**STAFF REPORT: MAY 14, 2025 MEETING**

**APPLICATION NUMBER: HDC2025-00114**

**ADDRESS: 2233 PARK AVENUE (AKA IODENT BUILDING)**

**SCOPE: REPLACE WOOD WINDOWS**

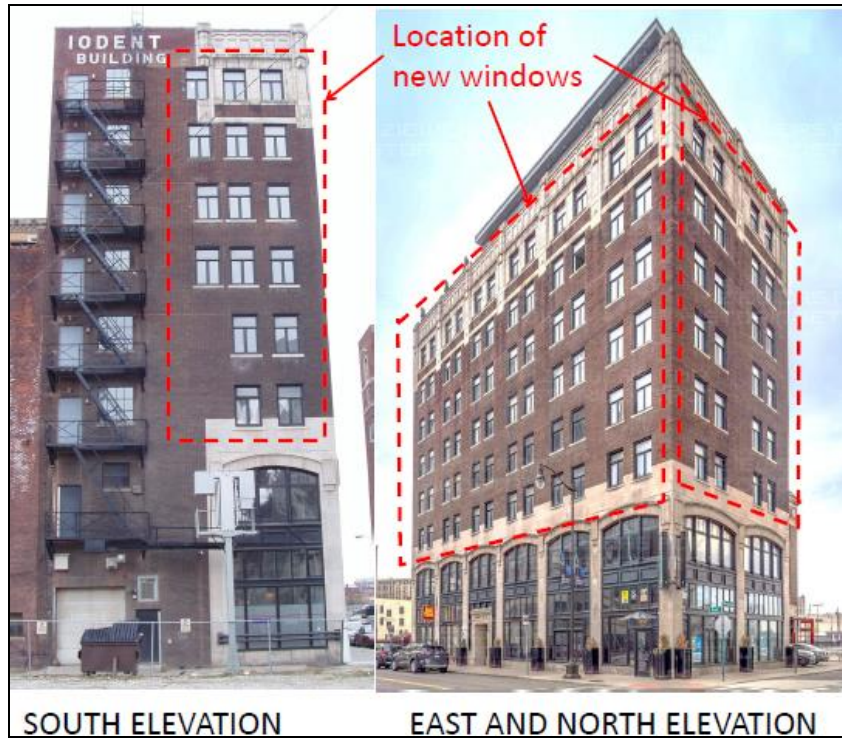
Above: and far left: Applicant materials. The yellow on the floor plan indicates windows to be replaced.

Pella Reserve, Traditional  
Cottage Style Single Hung Window  
Exterior aluminum clad black  
Interior painted white

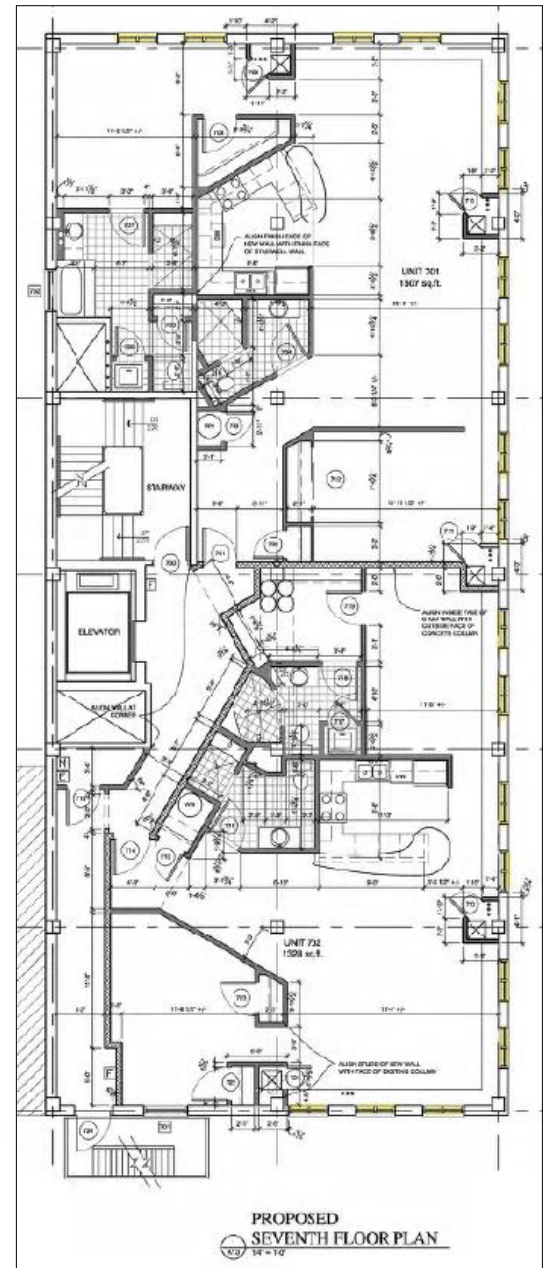
Left: Photo from Pella's website of a Pella Reserve Traditional window. It is offered with a wood or aluminum-clad, wood frame. This double-hung unit is the visual provided by Pella on their website as well as by the applicant. However, this is not the window specified within the application.

Far left: As shown within the applicant's project description, the cottage-style window is a single-hung window, so only the lower sash is operable.

- While the review of replacing the existing windows is premature, staff can offer comments on the selected replacement window. The application proposes to install “cottage-style” windows from the third through eighth floors on three sides of the building. The installation of this new window type would obliterate the distinctive, character-defining feature of the existing windows and would alter the features that characterize this building.
- Additionally, the proposal is to remove or cover all remaining details, including the profiled wood brick mould. The brick mould is one of the most visible components of a window opening due to its proximity to the masonry wall. Aluminum trim cannot be bent in such a way as to match the highly profiled wood brick mould. The flatter surface and sheen of aluminum is not compatible with a building erected in the early 20<sup>th</sup> century.

**Group A, Second Floor** – Both openings have matching highly profiled, and likely original, wood brick mould. The frames of the French windows at left have a visible top sash, whereas the top sash at right is minimally visible.

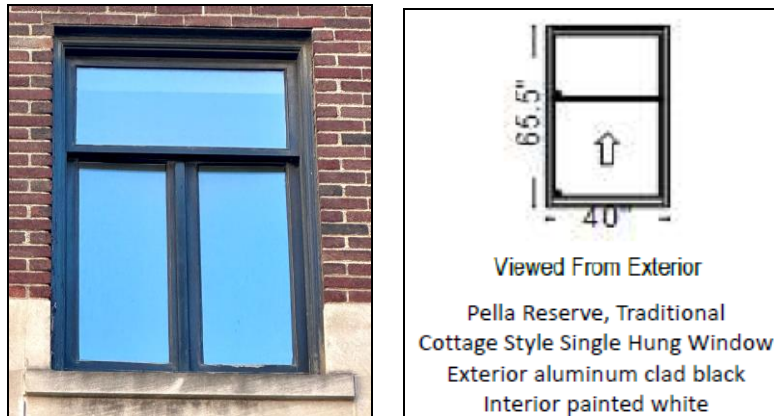
*The transom in the left window sits back in the window frame and has additional wood framing, creating a smaller glass area; the horizontal mullion is thin and offers some dimensional profile. In contrast, the transom at right sits forward in a uniformly flat frame and doesn't have a mullion. Staff photos, April 2025.*

**Group B, Third Floor** – Both openings again have matching highly profiled, and likely original, wood brick mould. Contrasting with Group A, the top sash of the French windows at left have the partially obscured top sash, and the window at right has the mostly exposed top sash.

The transom in the left window sits forward in a uniformly flat frame and doesn't have a mullion. The transom in the opening at right is a different (and now third) example of the glass extending to the outer window frame. There is a thin, deep mullion, but no dimensional trim as shown in the Group A window at left. Staff photos, April 2025.

- The submitted visual exterior analysis by staff shows that there is no clear understanding of what, if any, original historic material remains, beyond the brick mould. It is staff's opinion that before the Commission can consider any level of a window replacement project, a window survey documenting the details of each window opening must be completed.
